Soybean Processing and Biodiesel Production Facility

(Approval No. 08_0083)

Section 75W Modification Application

November 2012

Figure 2 – Summary of proposed changes

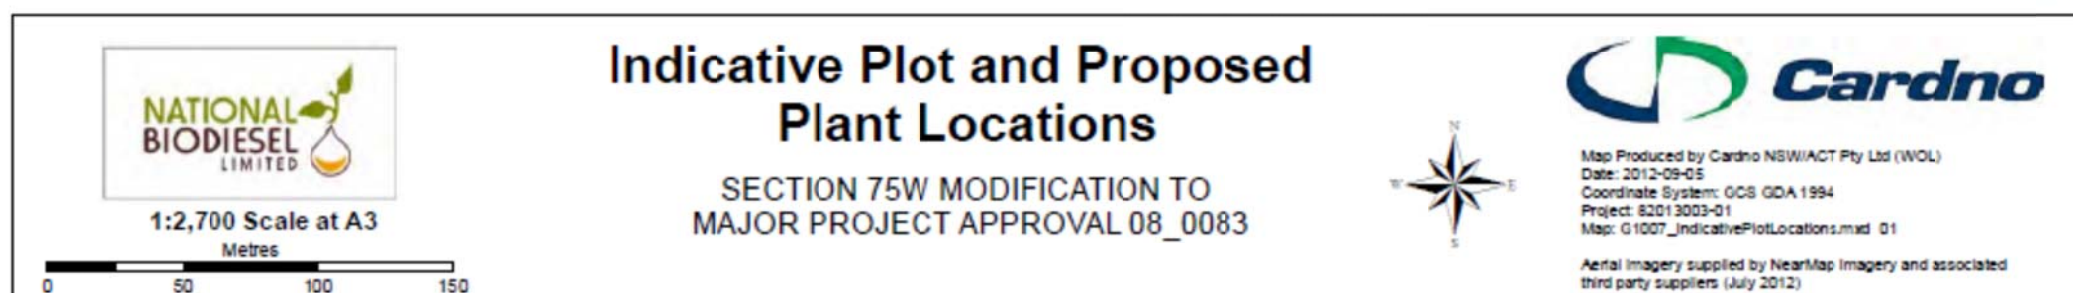
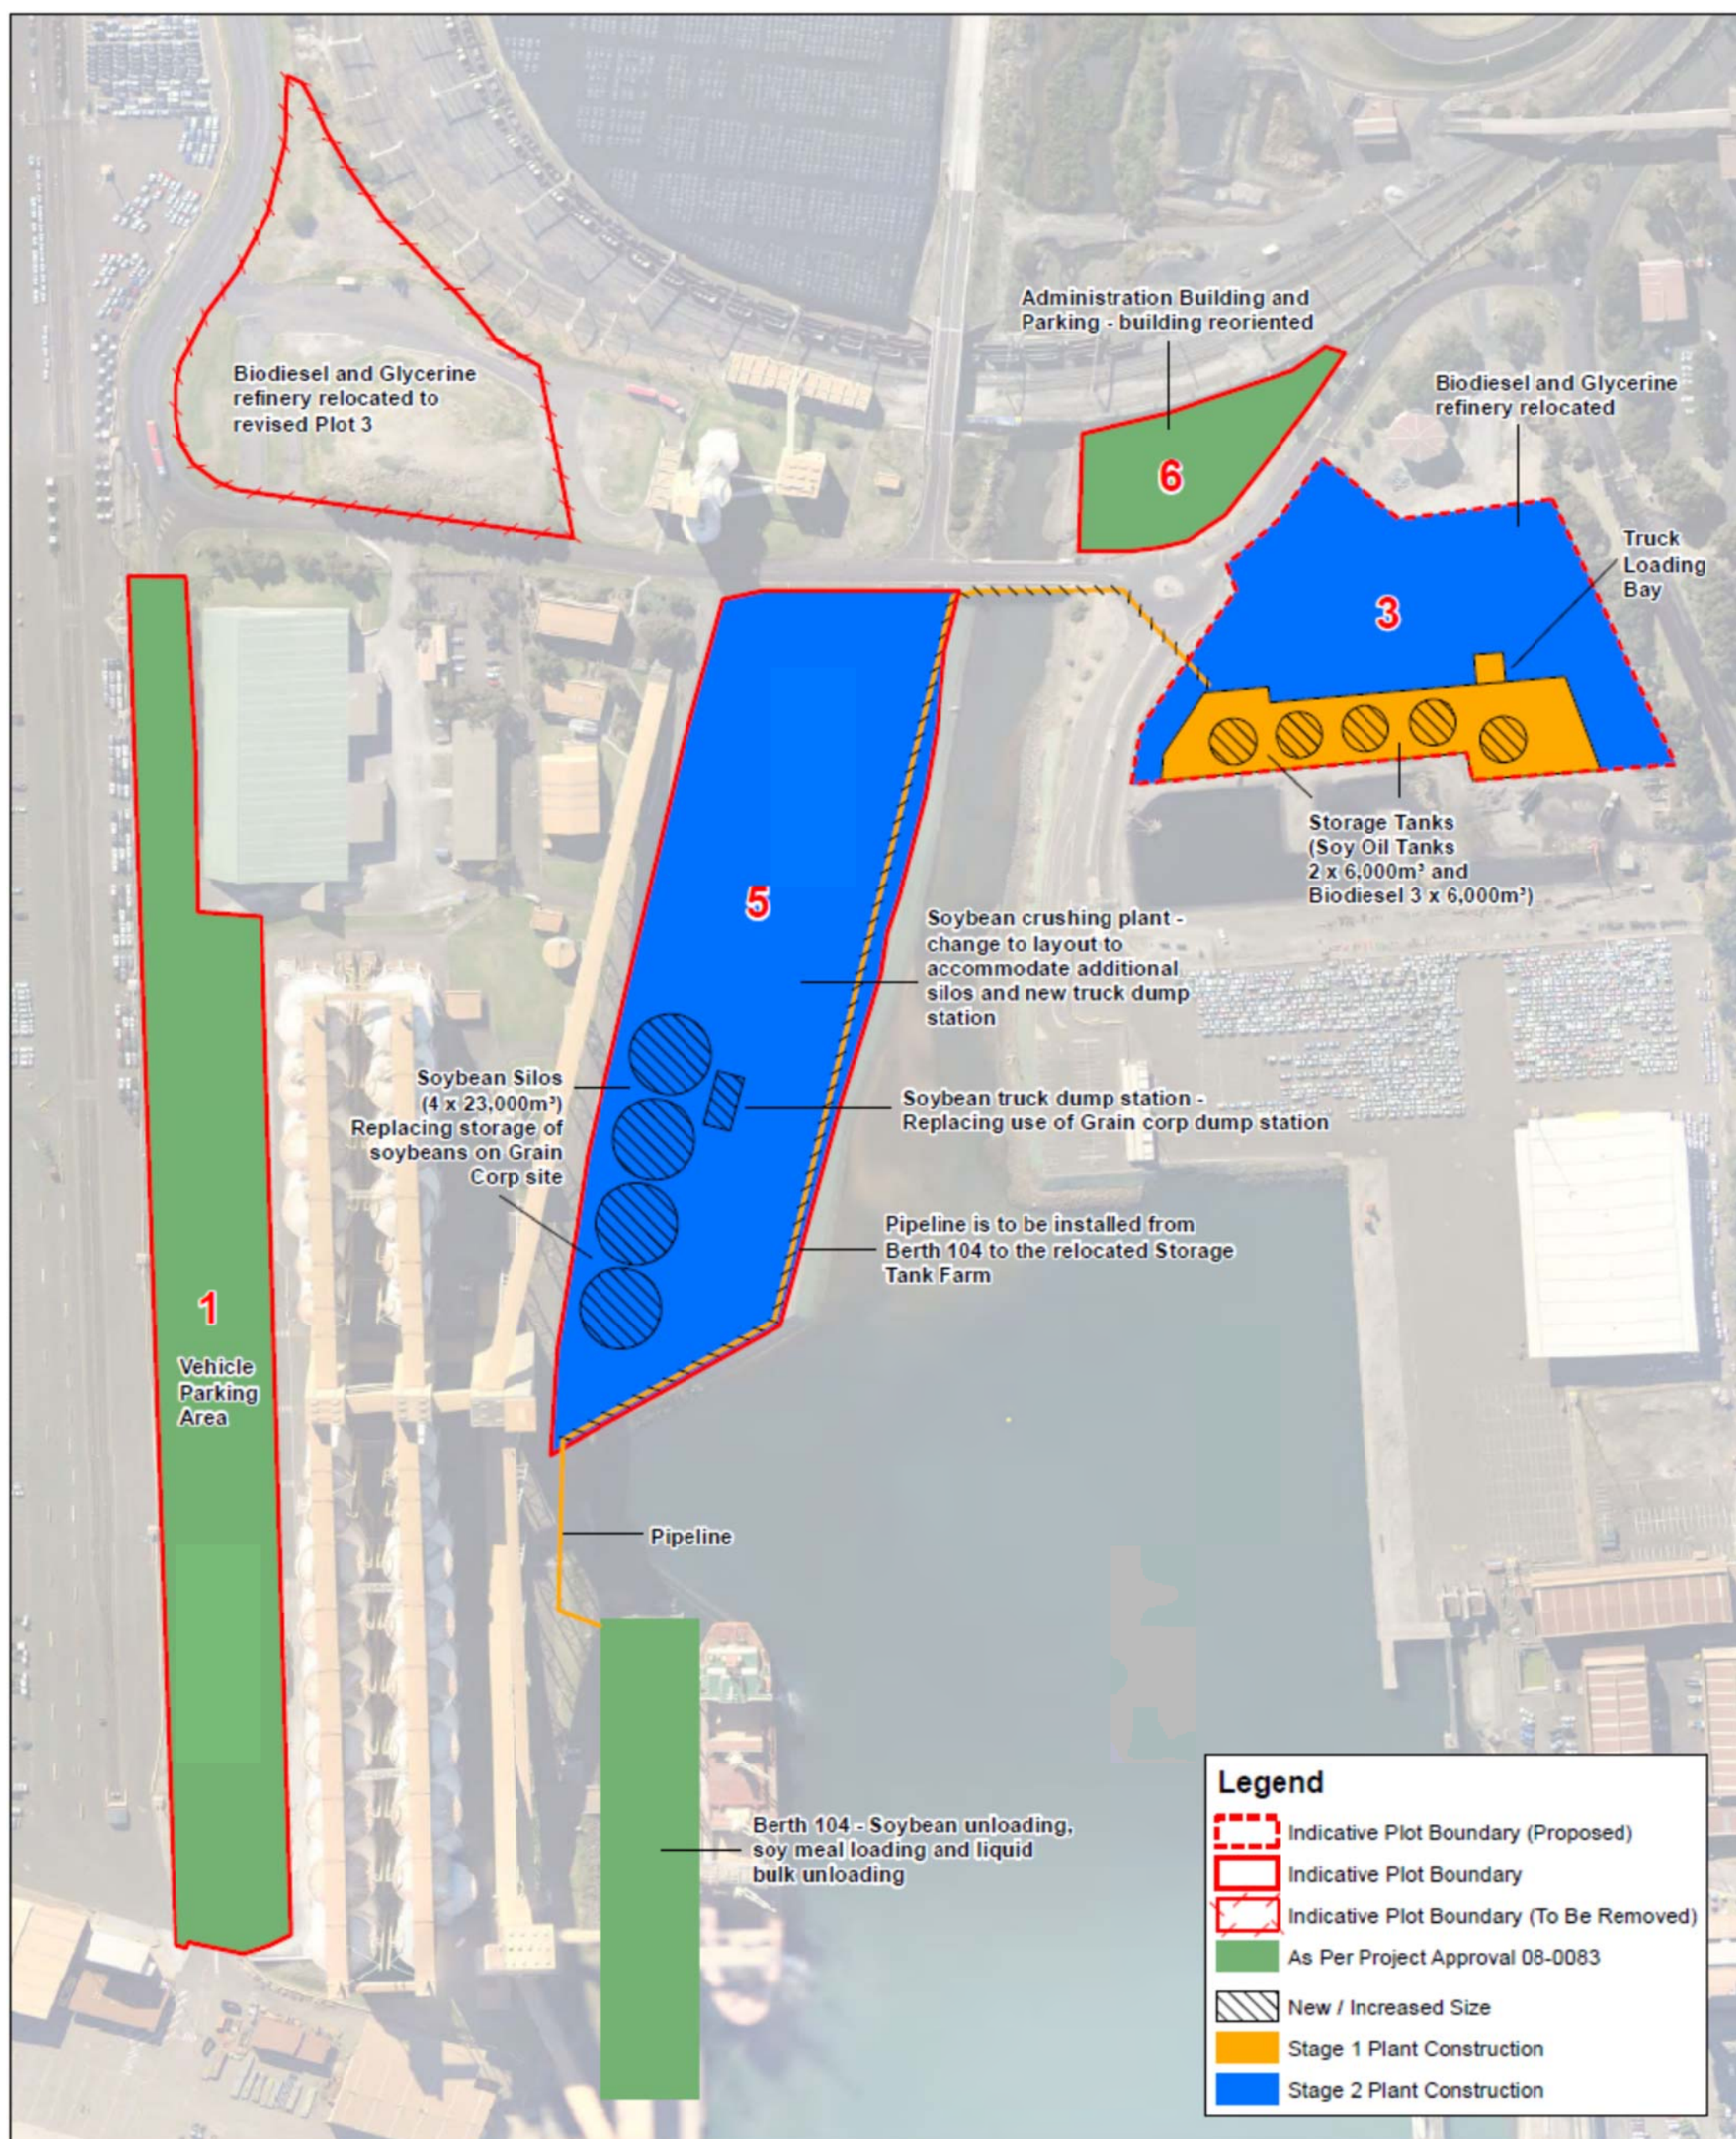
Change No.	Description	Original Project Approval (Approval No. 08_0083)	Proposed Change
1	Location and size of Plot 3, Biodiesel plant site	PT lot 20, DP1046295, 1.55 Ha land area	PT lot 2, DP 1125445, 1.8 Ha land area, located approximately 250m east of original Plot 3
2	Staged Construction of Plant	Plant to be built in a single stage	Plant to be built in two stages; <u>Stage 1</u> : liquid bulk storage and loading facilities <u>Stage 2</u> : Soybean Processing and Biodiesel Production facilities
3	Additional Bulk Storage Capacity for Biodiesel and Soybean Oil on Plot 3	3 x 5,600m ³ Biodiesel storage tanks located on Plot 3. 1 x 10,800m ³ ML Soybean Oil storage tank located on Plot 5.	3 x 6,000m ³ ML Biodiesel storage tanks located on Plot 3. 2 x 6,000m ³ Soybean Oil storage tanks located on Plot 3.
4	Liquid Bulk Unloading Facility at Berth 104	Ship unloading facilities at Berth 104	Addition of liquid bulk unloading facilities at Berth 104

5	Soybean Storage Silos and Truck Dump Station	Use of GrainCorp's existing facilities; 7 x 10,000t silos, 2 x 5,000t silos and a truck dump station	Construction of 4 x 20,000t soybean silos, truck dump station and associated conveyors on Plot 5.
6	Change in orientation of Administration Building and car parking	Admin building faced East/West, and car park located on Western side of the building	Admin building facing North/South, and car park located on Southern side of the building.

Figure 2 at the start of this report summarises this visually, highlighting the plant that will be constructed in Stages 1 and 2 respectively.

Figure 3 – Revised plant layout with proposed changes

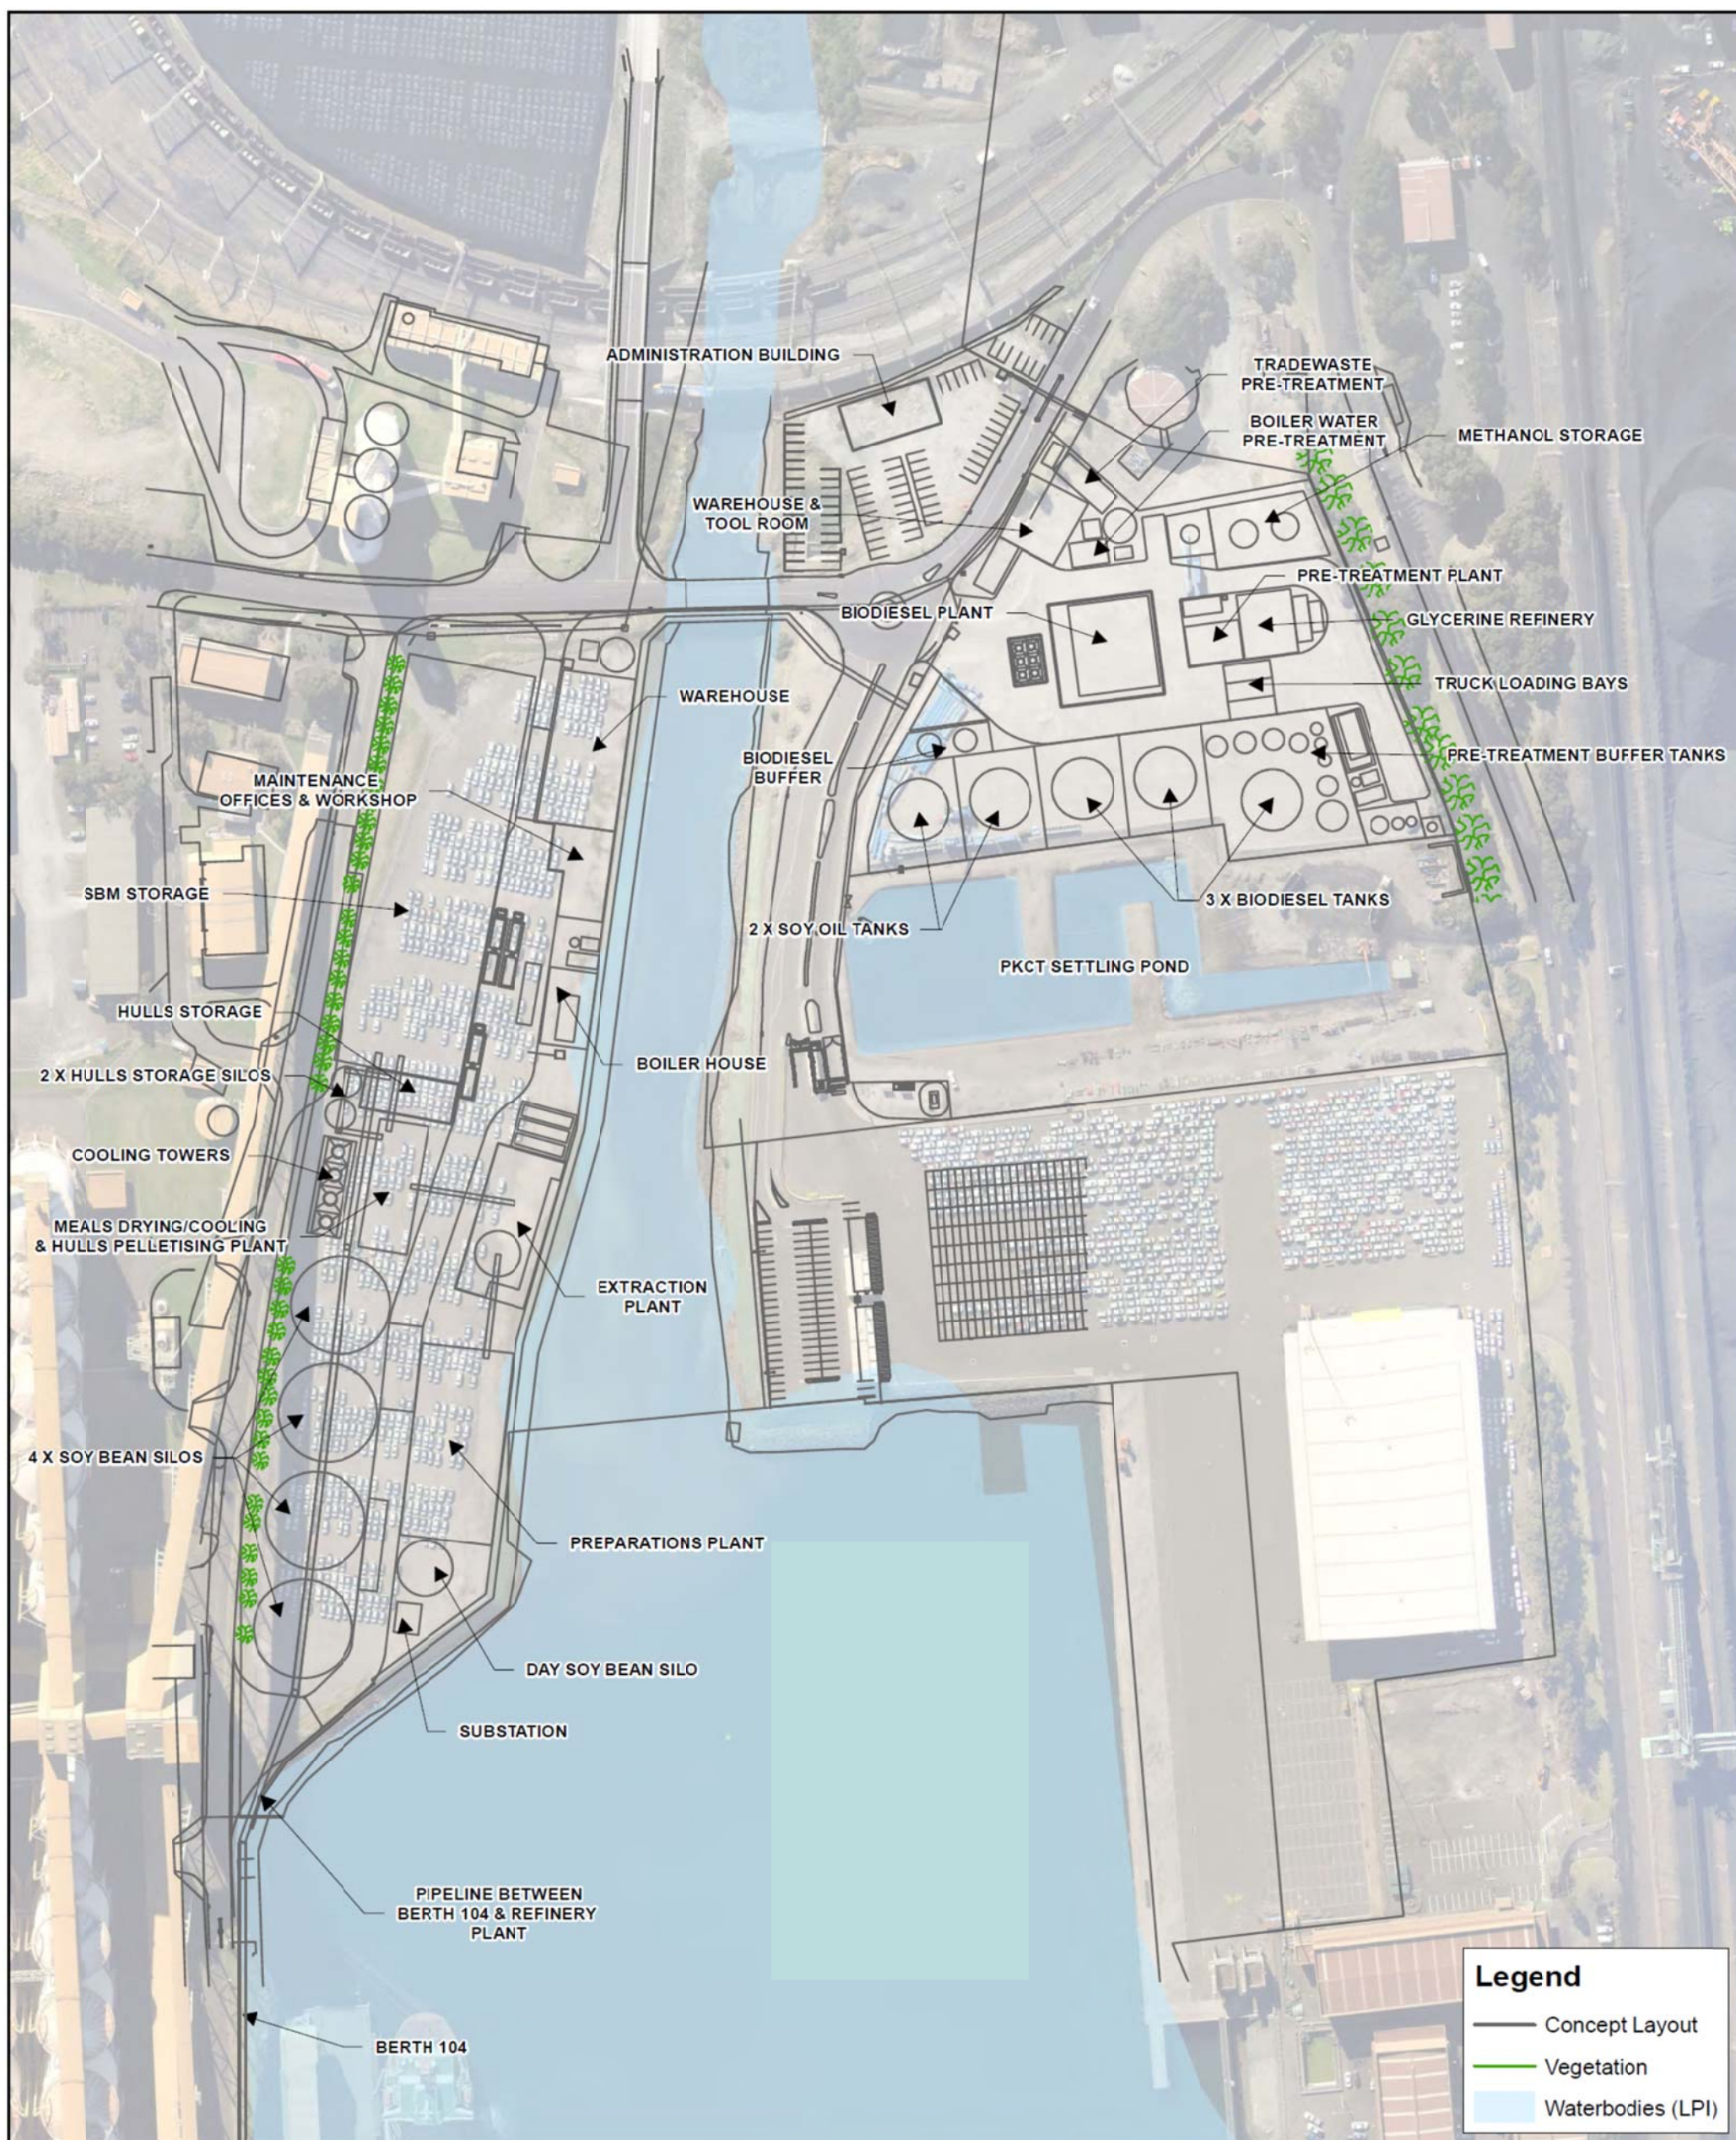
Figure 3 at the start of this report shows the revised concept layout for the Biodiesel Refinery site incorporating these slightly larger storage tanks on the new land plot, and it is also indicated in the visual summary of proposed changes provided in Figure 2.

Figure 3 at the start of this report shows the revised concept layout for the Crushing Facility site incorporating these new storage silos and new dump station, and they are also indicated in the visual summary of proposed changes provided in Figure 2.

Figure 3 at the start of this report shows the revised layout of the Administration building and car park.

Figure 4 – Change in location of Plot 3

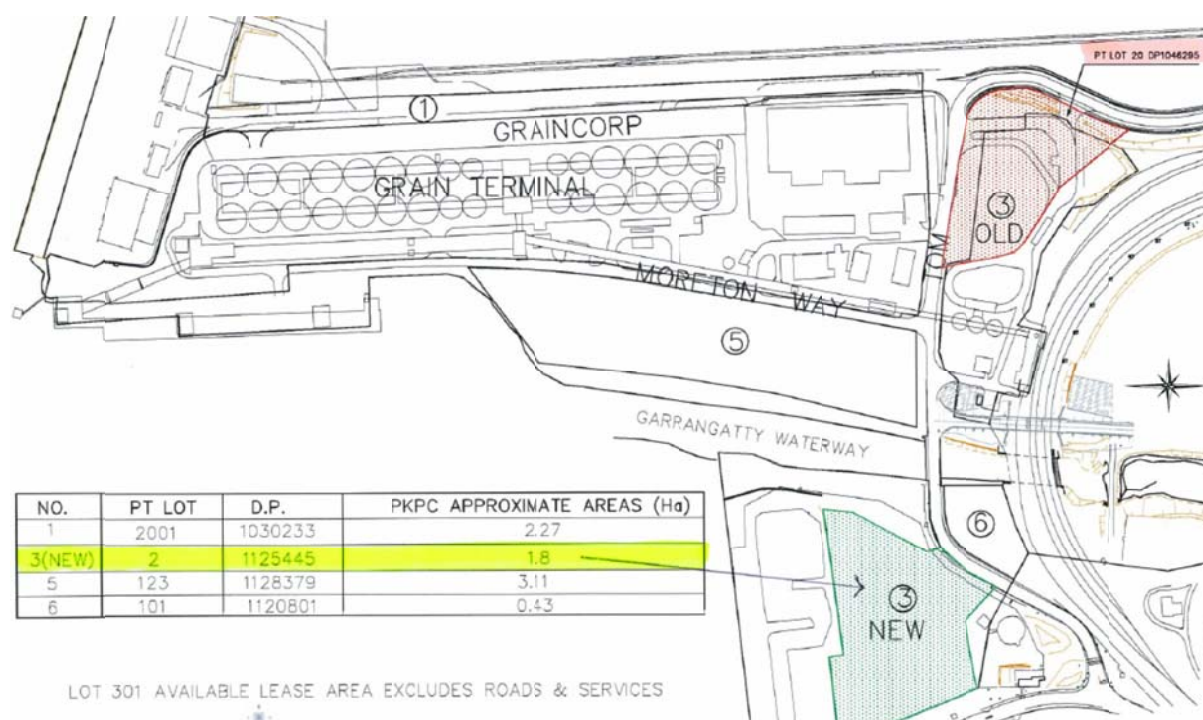
The land allotment for the Biodiesel Refinery, Plot 3, has changed in both location and size due to reallocation of lands by the Port Kembla Port Corporation (PKPC). The new Plot 3 is located approximately 250 east of the previously approved site, and is slightly larger in size (1.8 Ha for new Plot 3 vs. 1.55 Ha for old Plot 3).

The relative locations of the new and old locations of Plot 3 are shown in Figure 4 below, and Appendix 3.1 outlines this change in land plots in detail.
